**Derry City and Strabane District Council Planning Committee Report**

**APPLICATION NO:** J/2015/0059/F

**PROPOSAL:** Proposed installation of 1 no. 250KW wind turbine on a tubular tower of up to 50m (to hub height) with blades up to 77m (to tip height)

**LOCATION:** Lands 871m South East of 3 Bearney Road, Edenmore, Strabane

**LANDSCAPE VISUALISATION IMAGES**

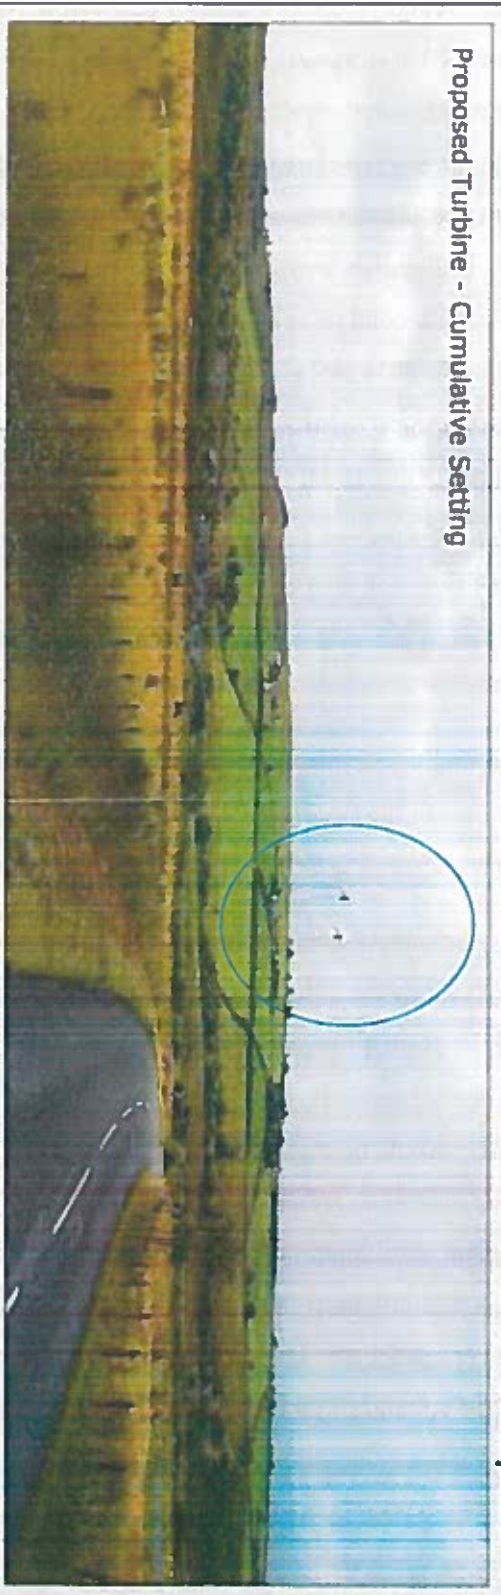
From the above vantage points and particularly from the A5, the proposed turbine will be sited on the mid slopes of the hill at a level approx. 50 metres below the crest of the hill. Although the turbine will not be sited directly on the skyline, the rotor and blades will project above the ridge of the hill. There are two turbines erected close to the apex of this hill, the first turbine J/2010/0216/F was granted by the PAC on the basis that the Commissioner gave substantial weight to the inter visibility of the turbine with manmade features on the skyline, distances involved in views from the A5 and intervening topography. The second turbine J/2014/0274/F was received prior to the current application and was therefore considered in sequential order in terms of visual and cumulative impacts. It was considered at that time that the J/2014/0274/F proposal was comparable to the adjacent PAC approval in terms of scale, degree of elevation, visibility from critical view points and inter visibility with other features on the hill and the proposal was therefore granted planning approval on this basis. The two approved turbines are also of a smaller scale with 40m hub heights. I consider the scale of the proposed turbine with a 50m hub height and 54m rotor diameter, with an overall height of 77m to tip, to be excessive in this context.

Viewpoint 1, possibly the most critical viewpoint, is located on the A5 where views from it are restricted by landform to a short stretch of the road when travelling from Sion Mills towards Strabane. From this short stretch of road, the landscape largely comprises of open views towards Carrigullan Hill. The proposed wind turbine would be clearly seen with the two consented wind turbines. However, there would be a gap between the consented and proposed wind turbines and they would not appear as a cohesive group. Because of this and taking account of the differences in their heights, the Planning Appeals Commission stated that "they would appear as a discordant ad hoc grouping in the landscape. Even though the range of visibility of the wind turbines would be limited, a large extent of the slopes of Carrigullan Hill would appear dominated by sporadic wind energy development from this part of the A5 and this would be unacceptable." The cumulative impact of the proposal would therefore result in an unacceptable detrimental impact on the landscape in this part of the Foyle Valley LCA.

At the time of the J/2014/0274/F approval, it was accepted that the area had the capacity to accommodate two turbines, however I feel that this landscape has now reached its capacity for turbine development and any further development on this hill would have a detrimental cumulative impact upon the visual amenity and landscape character of the area. The proposed turbine would be

inter visible with the two approved turbines. When viewed from the A5 as well as from the surrounding local road network, these developments would read as discordant grouping of ad hoc turbines. In this particular case, I do not consider that this upland landscape with views from the main A5 lends itself to wind farm developments of this nature and is therefore not capable of accommodating the proposed turbine in addition to the existing approvals on this hill.
